# Product Change Notification

## 113885 - 00

**Change Notification #:** 113885 - 00  
**Change Title:** Intel® Server System R1304WTTGS, R1208WTTGS, R2208WTTYS, R2208WTTYC1, R2308WTTYS, R2312WTTYS, R2224WTTYS, R1304WT2GS, R1208WT2GS and R2208WT2YS  
Intel® Server Chassis R1304WTXXX, R1208WTXXX, R2000WTXXX and R2312WTXXX  
PCN 113885-00, Product Design  
Update BIOS/ME/BMC/FRUSDR Firmware, update the IO connector, remove the resistor, update the screw hole and add the mylar plastic  
**Date of Publication:** June 12, 2015

Figure 1

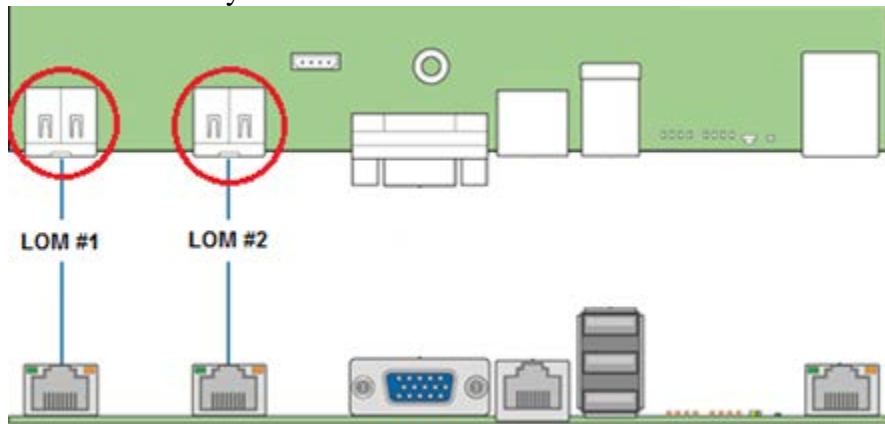
6. For Intel® Server System R1304WT2GS, R1208WT2GS and R2208WT2YS, update the Intel® Server Board S2600WT2 Printed Board Assembly (PBA) revision from H21573-360 to H21573-361.
7. Update the RJ45 connectors for onboard LAN ports 1 and 2 to improve the LAN cable connectivity. The locations of the IO connector are shown as Figure 1:

Figure 2

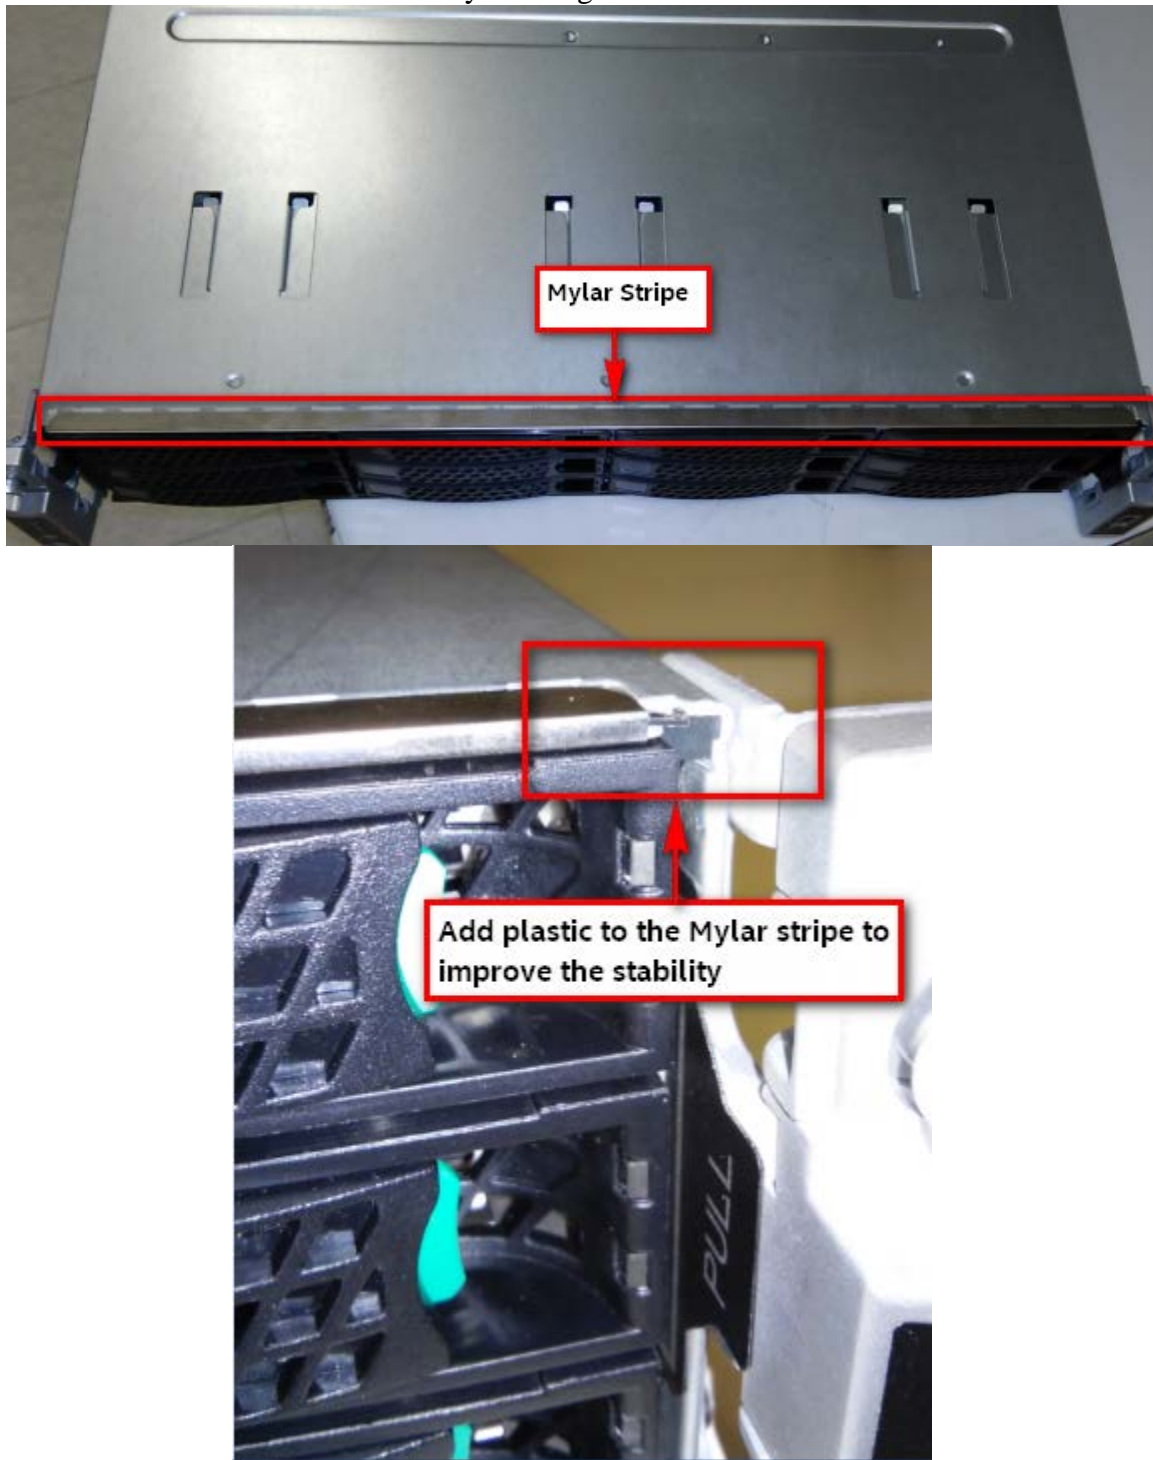
8. Adding support for Battery Backup Units (BBUs) compatible with Adaptec\* RAID cards. Adaptec ready BBUs can now be mounted to the Intel® RMFBU mounting plates that ship with the system.
9. Add the Mylar plastic on the bottom of the hard disk carrier bay to improve the fit of the chassis mechanical assembly. See Figure 2:

1. Adding support for Battery Backup Units (BBUs) compatible with Adaptec\* RAID cards. Adaptec ready BBUs can now be mounted to the Intel® RMFBU mounting plates that ship with the system.
2. Add the Mylar plastic on the bottom of the hard disk carrier bay to improve the fit of the chassis mechanical assembly. See Figure 2.
